**Medway DPW Water Quality Treatment  
Facility Site Plan – 19 Populatic Street**

**SUBJECT: Populatic Water Treatment Plant – Major Site Plan Review  
19 Populatic Street, Medway, Massachusetts**

Wright-Pierce has received Tetra Tech's comments on the Major Site Plan Review submission for the Populatic Water Treatment Plant project. We have prepared the following letter and attachments in response to these comments.

DRAWING  
**C-4**

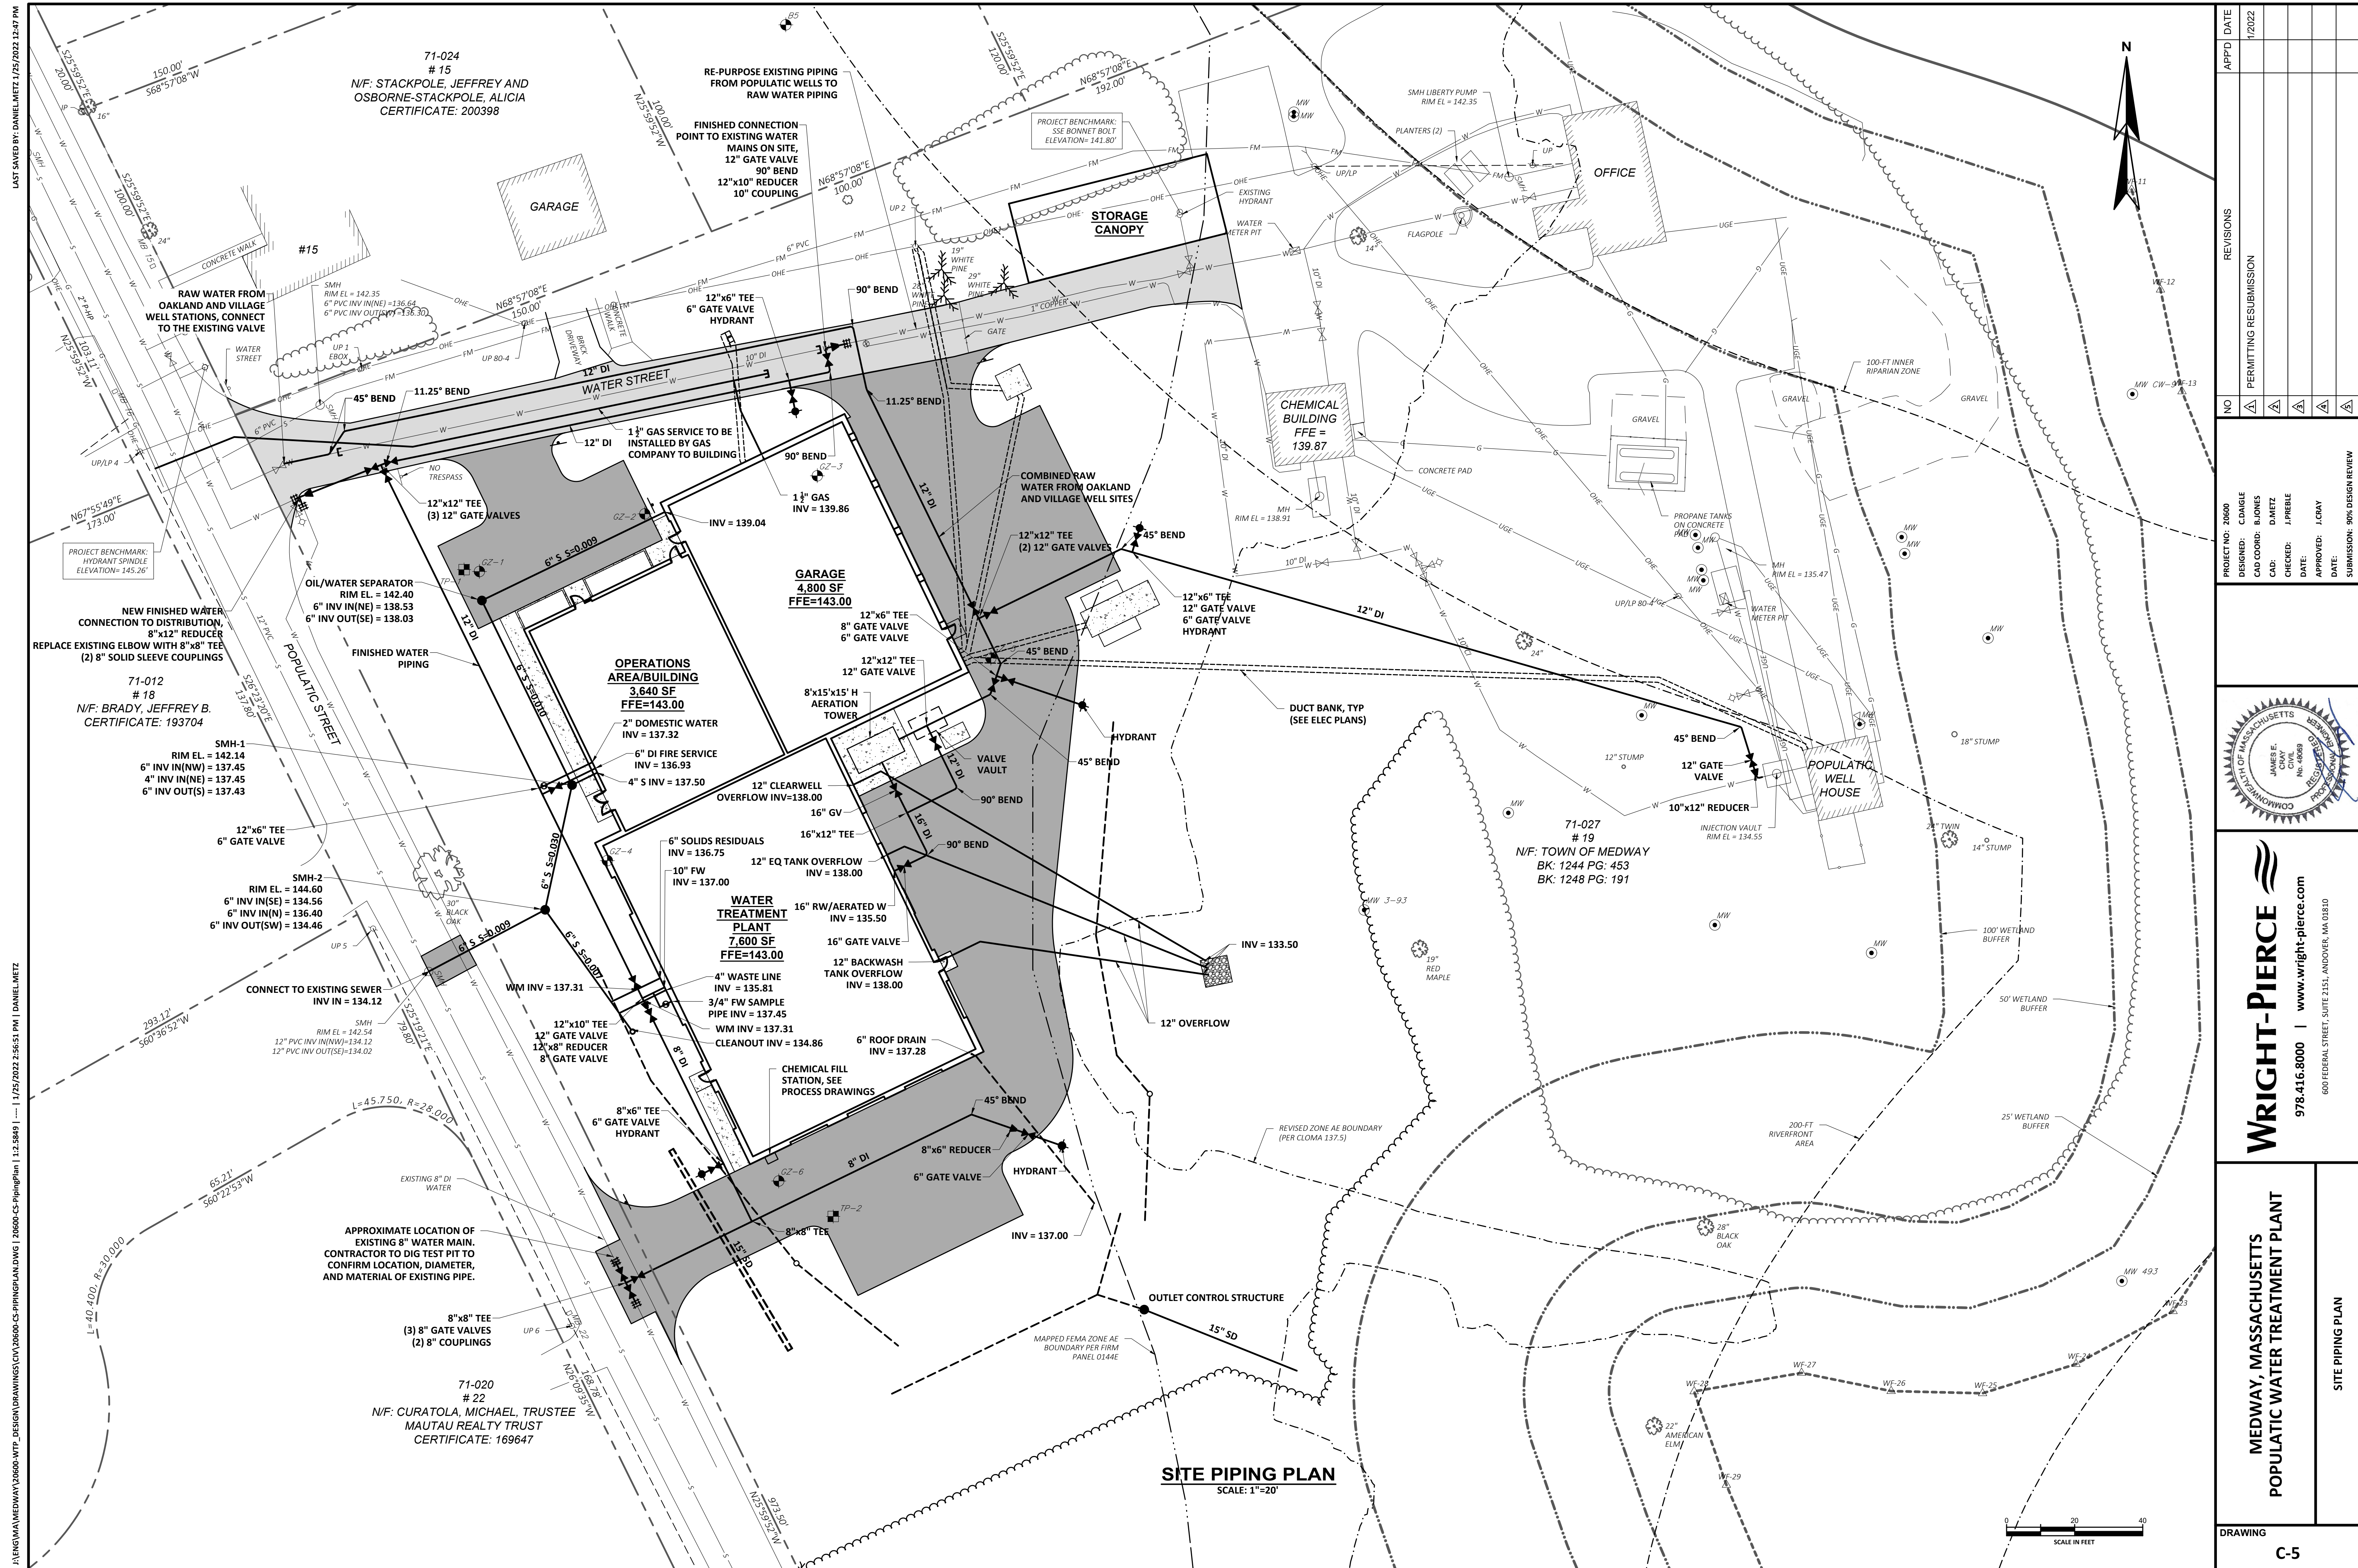
3. Earth removal calculations are not provided in the Plans. (Ch. 200 §204-3.I)

4. Earth fill estimates are not provided in the Plans. (Ch. 200 §204-3.J)

***Response: Earth removal calculations have been added to Sheet C-4. Revised drawings are included as Attachment C.***

***Response: Earth fill estimates have been added to Sheet C-4. Revised drawings are included as Attachment C.***

SITE CUT AND FILL			
	CUT	FILL	NET
BUILDING EXCAVATION AND GRADING	4143 CY	1897 CY	2246 CY CUT
FLOODPLAIN EL 132.0 TO 137.5	596 CY	218 CY	378 CY CUT
